**FIELD SERVICE BULLETIN**

FSB Number: LVCCFSB2005-289  
Authors: Darwin Garcia  
Date: September 15, 2005  
Total No. of Pages: 3  
Subject: **V3 CLI ITO Corrosion WinTek**  
Model Affected: **V3**  
Level of Repair: 3 & 4

A corrosion area      B corrosion area

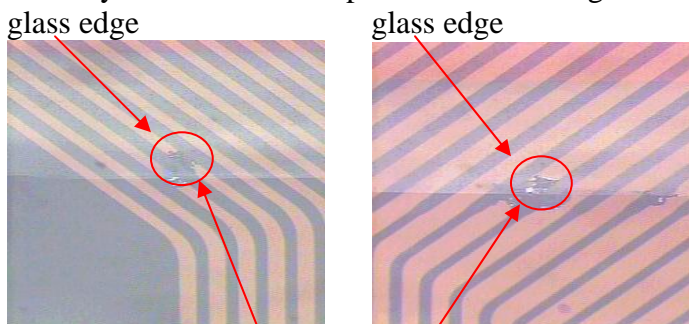
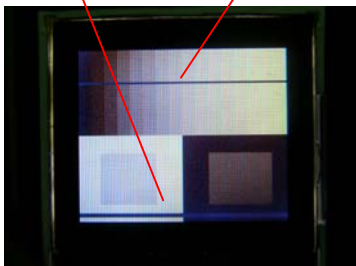
Service has been made aware of a V3 WinTek CLI ITO Corrosion Issue causing “No CLI Display” or “Display Secondary - Missing Pixels / Ico” complaints.

The root cause was determined to be corrosion on ITO circuits near the external cell gap and they are related to the positions of missing line.

After more in-deep analysis it was determined that the key factors that can cause ITO corrosion are the LCD cleaning and ITO exposure time.

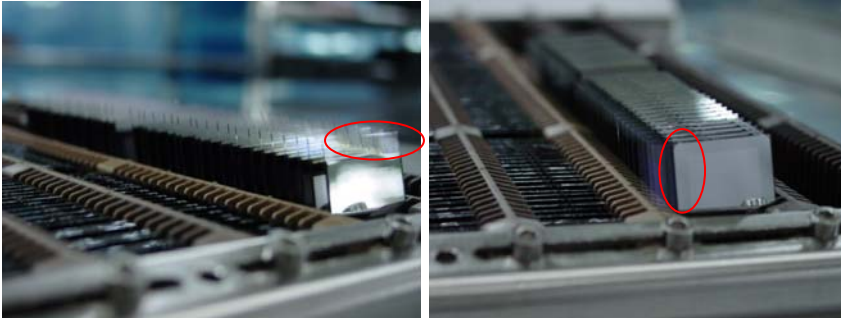
WinTek have revised their SOP as below:

1. Change the LCD putting method at cleaning rack. The outer pin of the LCD switches from upward to leftward position. It's to reduce the possibility of the particle residue in the external cell gap.

Upward

Leftward

**Date Code (3<sup>rd</sup> Row): XXXXX/XX**  
**Good Date Code: 05XXX/05 and later**

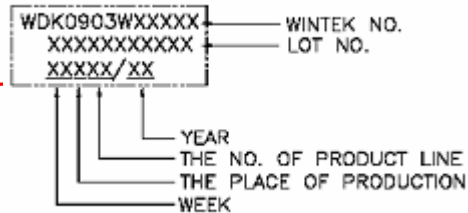
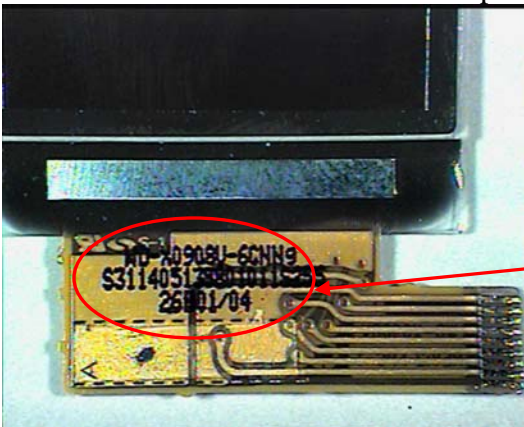
The corrective action was implemented on 1/28/2005, so all CLI modules manufacture after date code 05XXX/05 has the improvement.
